Request for Additional Information No. 430(4801), DRAFT

Question 10.02-10

U.S. EPR Standard Design Certification

SRP Section: 10.02 - Turbine Generator

Figure 10.02-10-1—Overspeed Protection System Schematic

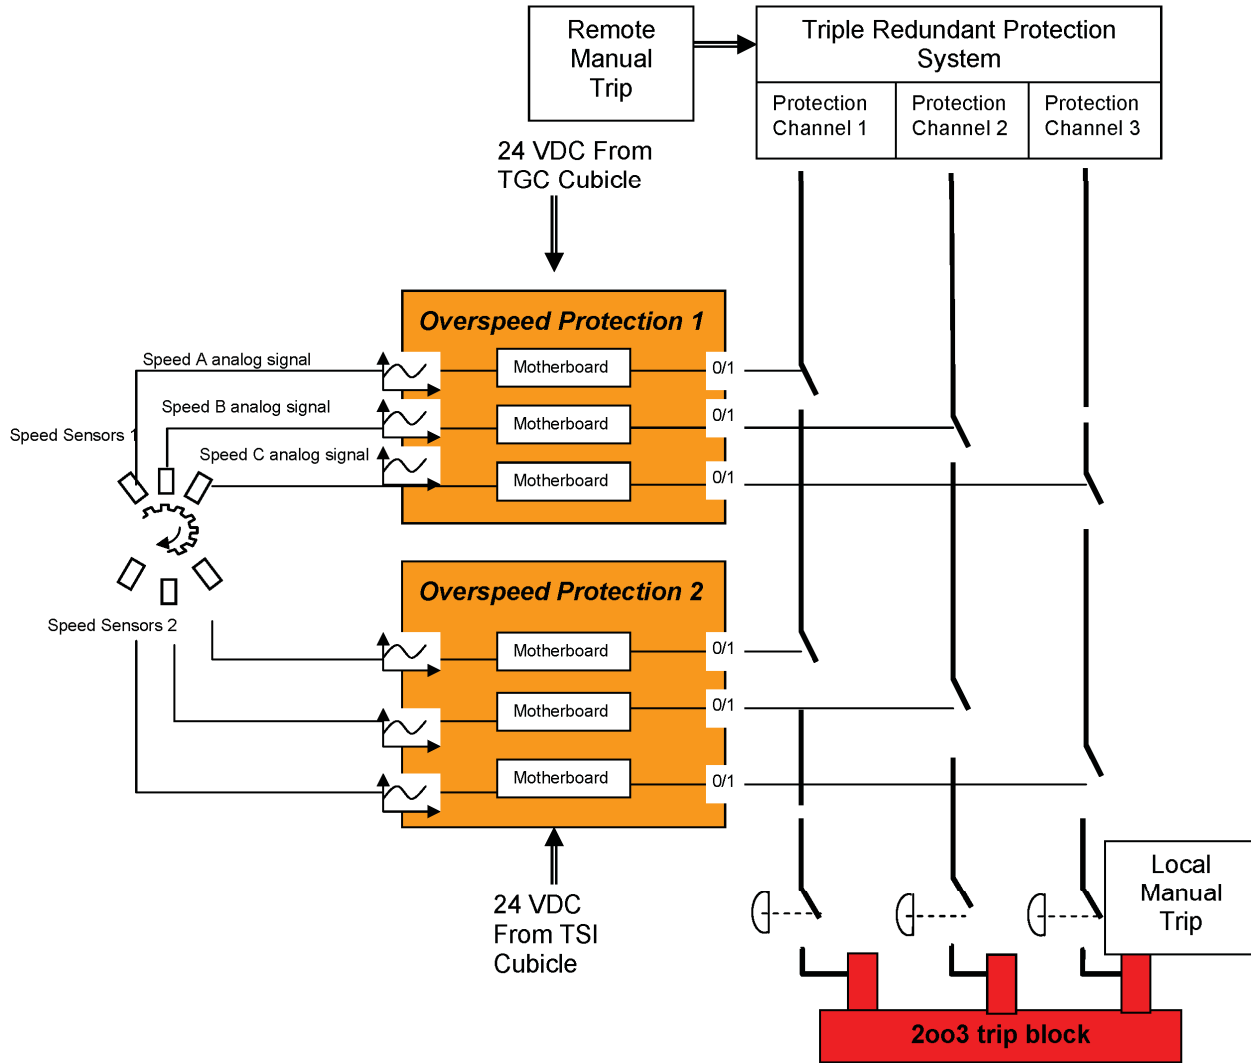
- 3) The FSAR needs to include a description of the local (at the turbine) and remote (in the control room) manual turbine overspeed trip circuits, including how they interface with the turbine overspeed protection systems and testing that is performed to assure functional capability over the life of the plant.

- 6) The response to RAI 10.2-7 included Tier 2 Figures 10.2-2 and 10.2-3 in proposed FSAR markups. However, these figures are incomplete in that they don't indicate if they represent the tripped configuration or the normal operating configuration, and the designations of "E" and "S" on Figure 10.2-3 are not defined. Also, the hydraulic interface with the trip block seems to be a single flow path in some areas which does not satisfy design considerations with respect to independence and redundancy, and small hydraulic flow passages could be subject to flow blockage. Furthermore, the response to RAI 10.2-6 indicates that the trip block dumps hydraulic fluid to a hydraulic tank which causes a low pressure signal to be sent to a safety relay for each turbine steam admission valve actuator. These safety relays cause hydraulic fluid to be dumped from the valve actuators for the turbine steam admission valves resulting in valve closure. From the figure and related description in the FSAR, it is not clear that this is accomplished and in particular, that independence and redundancy is provided by the design in this regard. The FSAR and figures need to be revised to provide a more clear description. Similarly, this sort of information needs to be provided for the extraction steam NRVs that are relied on for preventing turbine overspeed.

The local and remote manual TT circuits are totally independent of the overspeed protection systems. Figure 10.02-10-1 shows that the local and remote TT circuits do not act on the overspeed protection system channels, but directly on the trip channels.

In U.S. EPR FSAR, Revision 3, U.S. EPR FSAR Tier 2, Figure 10.2-2 was replaced by Figure 10.02-10-1 shown in this response.

As noted in the Response to Question 10.2-10, Item (3), U.S. EPR FSAR Tier 2, Figure 10.2-2 was replaced by Figure 10.02-10-1 in this response. This schematic also shows the tripped position.

Figure 10.02-10-2
Control System Architecture and Interface Chart

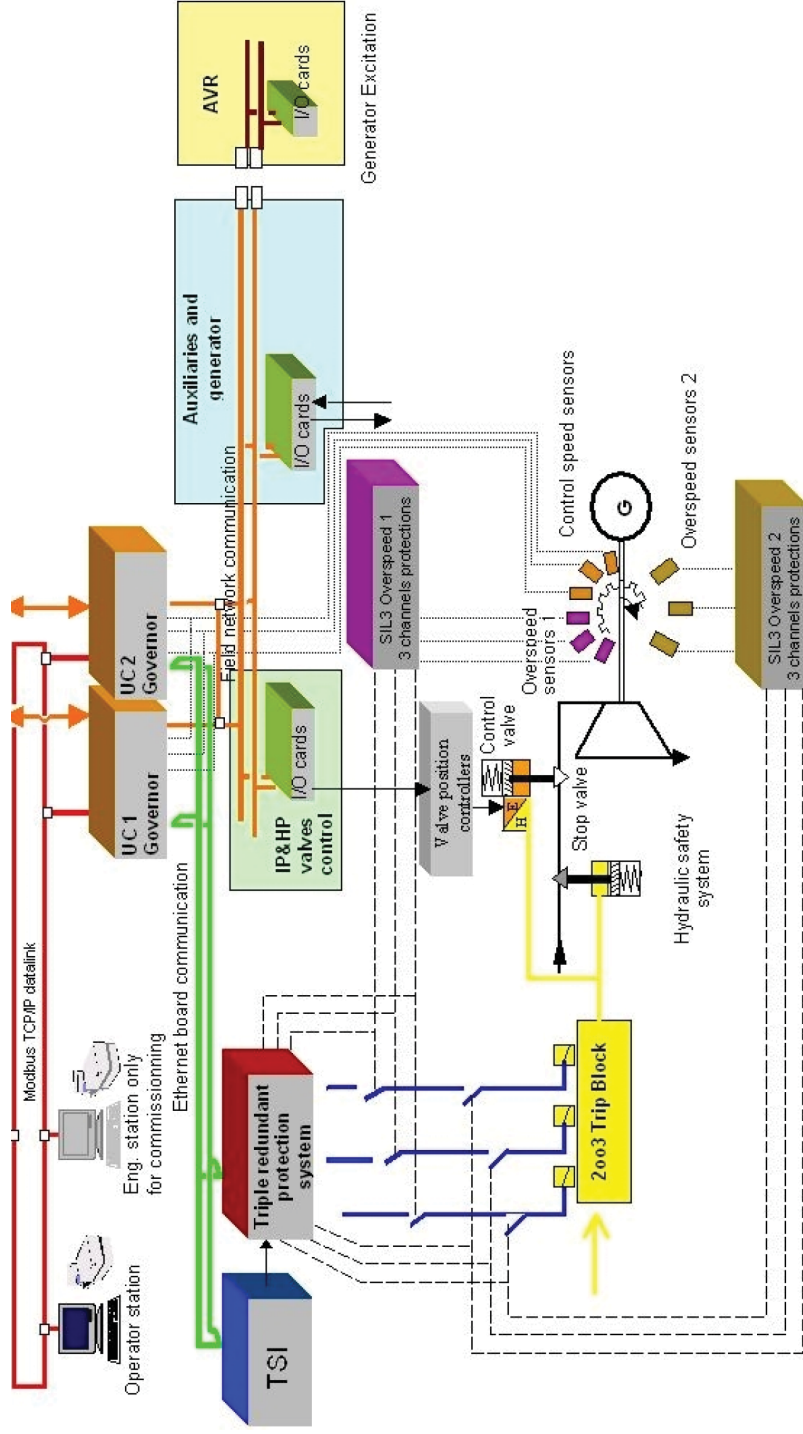
- 4) The response to RAI 10.2-6 indicates that the normal turbine generator speed control governor is independent of the turbine overspeed protection systems, but the design is not adequately described in the FSAR. The FSAR needs to include a description of the normal speed control system for the turbine generator, including major components that are included in the design and the system functioning and interfacing with other systems to prevent a turbine trip following a load rejection during full power operation.

The architecture of the control system is shown in Figure 10.02-10-2. There are two sets of three overspeed protection sensors, one set of three control speed sensors, and one spare speed sensor which is not shown. The two sets of overspeed protection sensors are connected to two separate electronic overspeed protection systems, with no common or shared components and powered by two separate power sources. Each overspeed protection system processes the sensors analog signals in three logic signals for the command of three relays on the three trip channels. These three logic signals are also sent to the triple redundant protection system, which will also order a TT in case of a turbine overspeed.

The three control speed sensors are independent of the overspeed protection systems. The analog signals from these sensors are sent to the two redundant speed governors, located in the turbine generator controls cubicle, and processed to give main steam and reheat control valve position commands. The two-speed governors provide on-line redundancy in a hot standby arrangement.

The redundancy of the speed governors allow for safe valve control. If one speed governor fails, the second speed governor still measures speed and controls the valve position. If both speed governors fail, the triple redundant protection system will order a TT, providing an overall control system that is fail-safe.
